ADDENDUM

Date Issued:	January 11, 2022
Project:	Intermountain Healthcare IMC- Cath Lab #1 Remodel 5121 South Cottonwood Street Murray, Utah 84107
Addendum Number:	1

Intermountain Healthcare
IMC- Cath Lab 1 Remodel Project

NJRA Project # 202229
Construction Documents December 15, 2021
ADDENDUM 1 JAN 11, 2022

A111

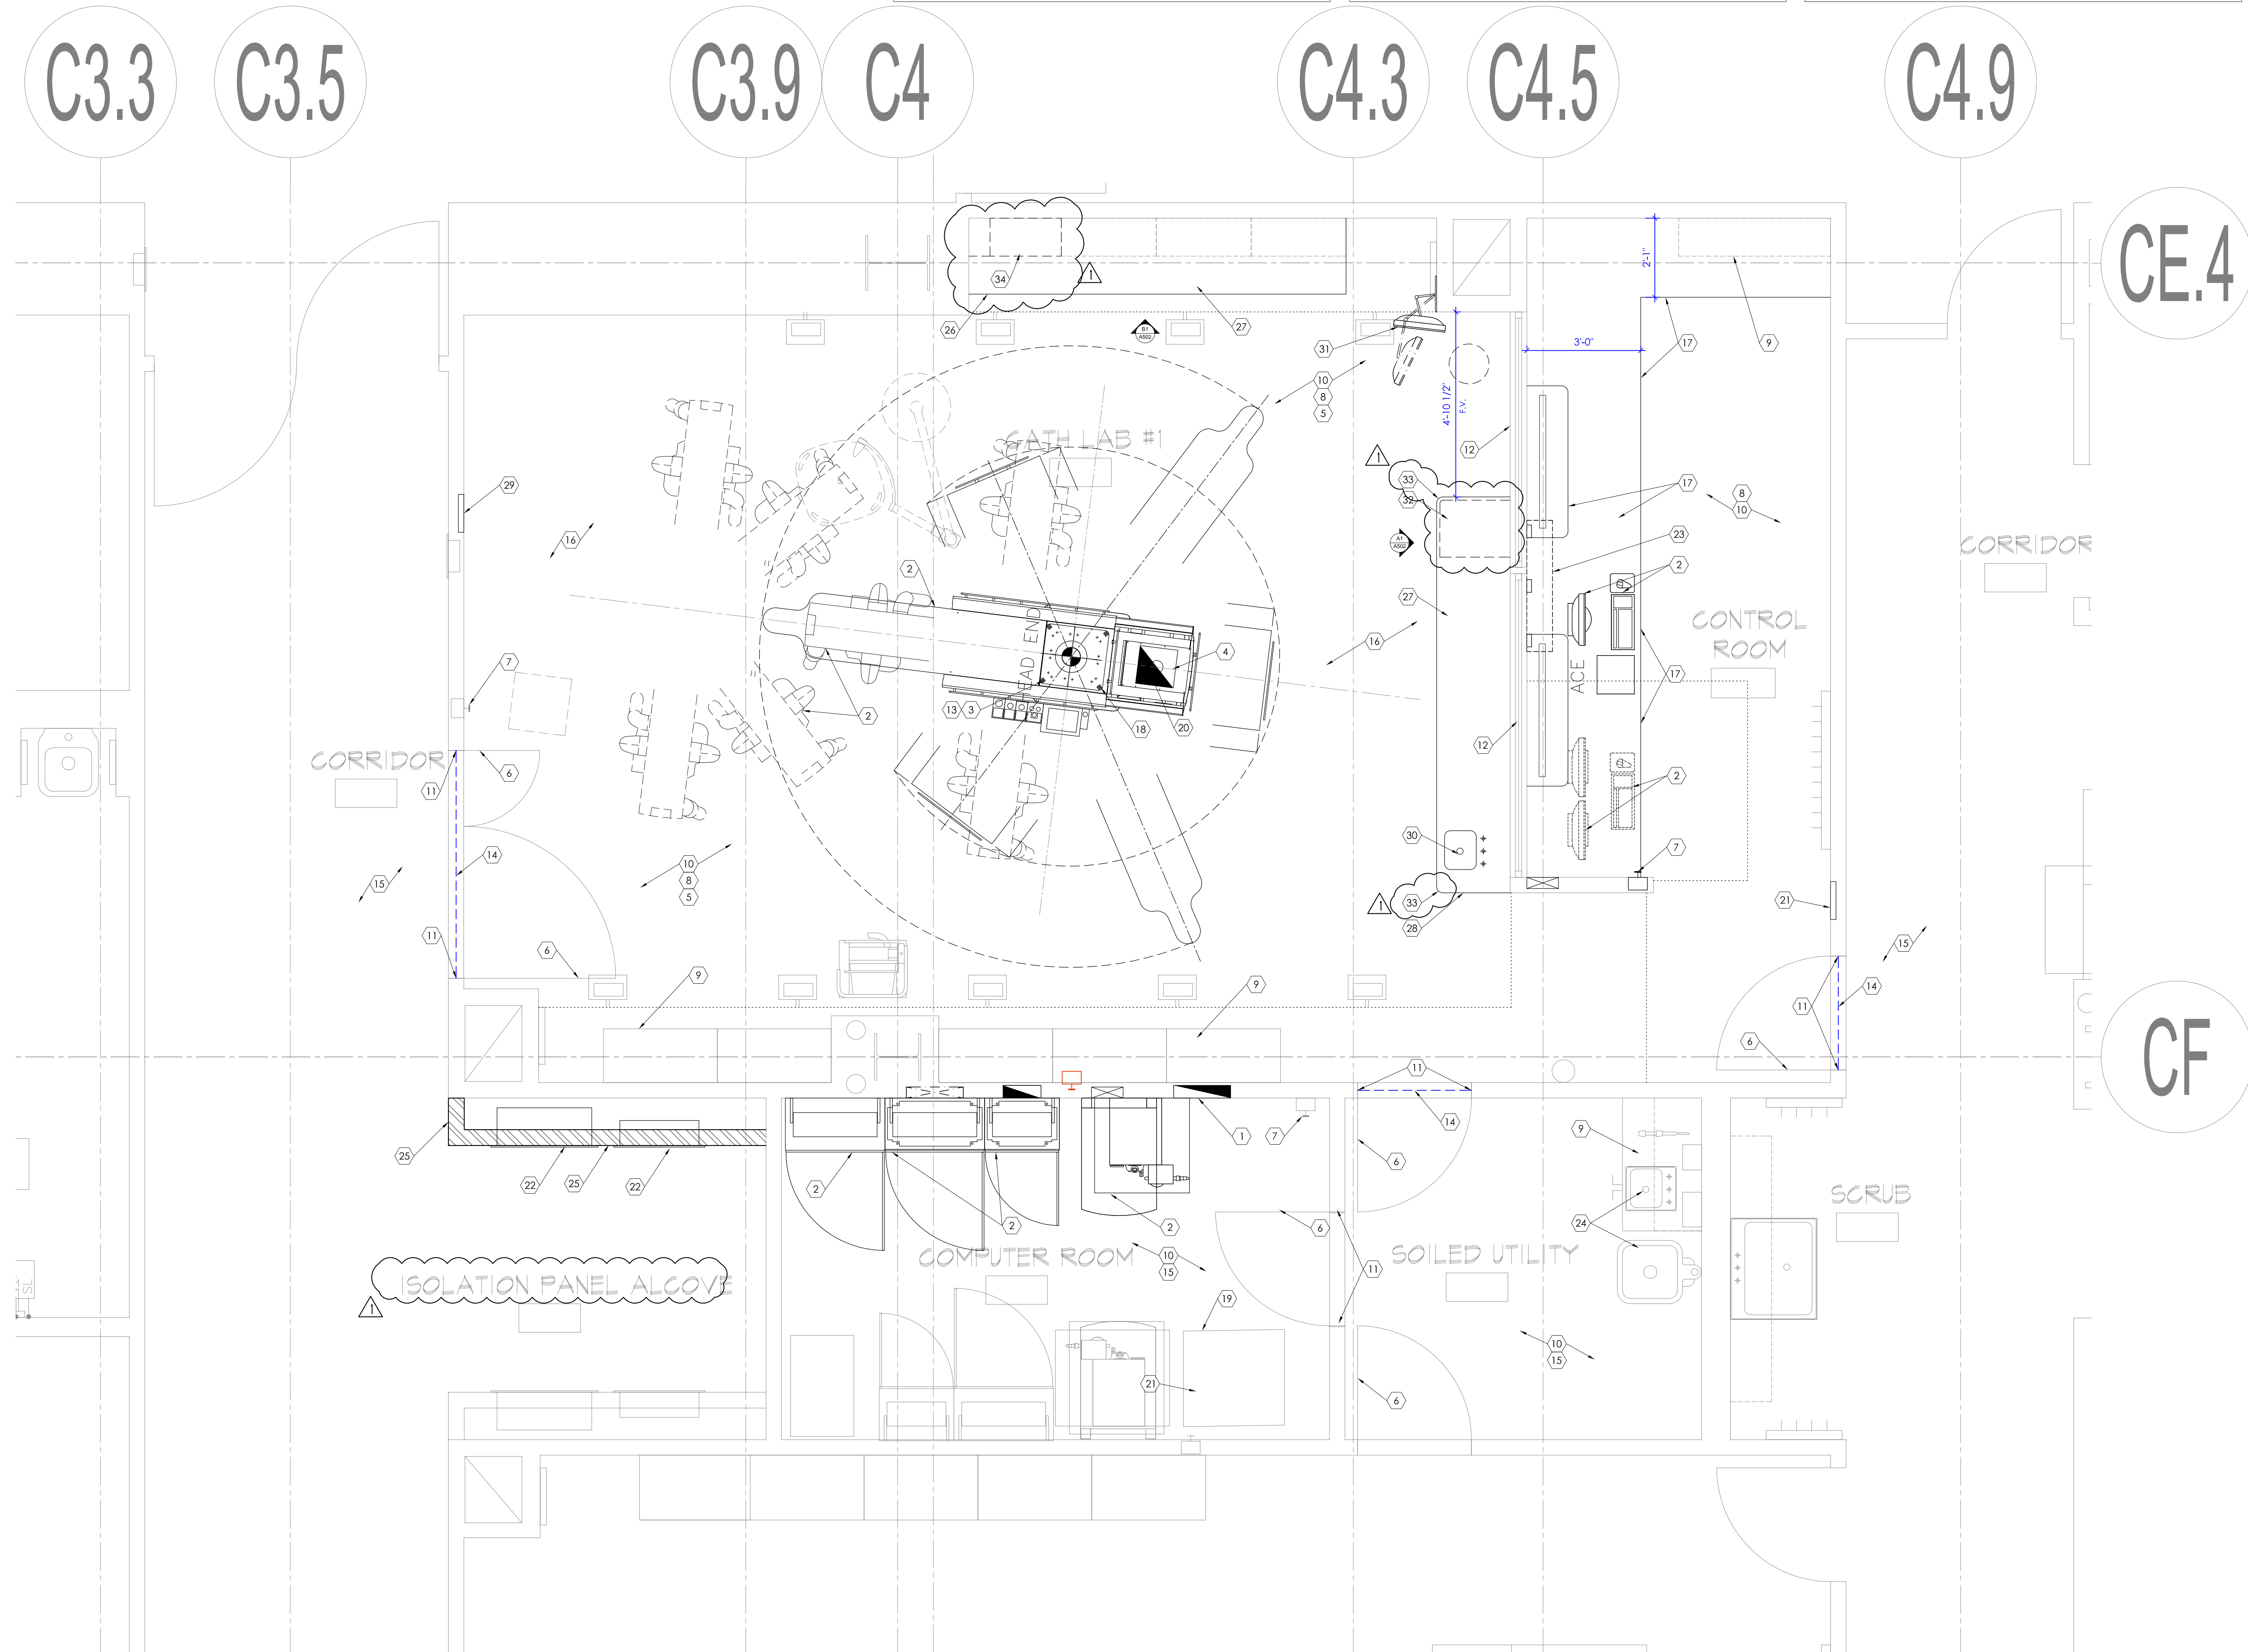
Sheet Number	Drawings
Architectural	
A111	New cabinet and millwork called out in the drawings have been revised. See attached sheet with revisions shown clouded.
A502	Detail and elevation for the cabinet has been revised. See attached sheet with revisions shown clouded.

- NEW PLASTIC LAMINATE BASE CABINET TO REPLACE EXISTING UNDER COUNTER CABINET. CABINET SHALL MATCH ADJACENT EXISTING. SEE INTERIOR ELEVATIONS AND DETAILS ON SHEET A502. PROVIDE REQUIRED WALL BACKING. PATCH AND REPAIR EXISTING LEAD LINED WALLS TO ORIGINAL CONDITION AFTER ALL WORK IS COMPLETED TO RETAIN SHIELDING.
- PROVIDE 2" RADIUS ROUNDED CORNER AT THE SOLID SURFACE COUNTERTOP.
- NEW PLASTIC LAMINATE UPPER WALL CABINET. CABINET SHALL MATCH ADJACENT EXISTING. SEE INTERIOR ELEVATIONS AND DETAILS ON SHEET A502. PROVIDE REQUIRED WALL BACKING. PATCH AND REPAIR EXISTING LEAD LINED WALLS TO ORIGINAL CONDITION AFTER ALL WORK IS COMPLETED TO RETAIN SHIELDING.

- NEW PLASTIC LAMINATE BASE CABINETS TO REPLACE EXISTING UNDER SINK CABINET. CABINET SHALL MATCH ADJACENT EXISTING. SEE INTERIOR ELEVATIONS AND DETAILS ON SHEET A502. PROVIDE REQUIRED WALL BACKING. PATCH AND REPAIR EXISTING LEAD LINED WALLS TO ORIGINAL CONDITION AFTER ALL WORK IS COMPLETED TO RETAIN SHIELDING. MEET ALL REQUIREMENTS SET BY THE AUTHORITIES HAVING JURISDICTION FOR DISPOSAL AND WORKING WITH LEAD SHIELDED WALLS WHERE NEEDED.
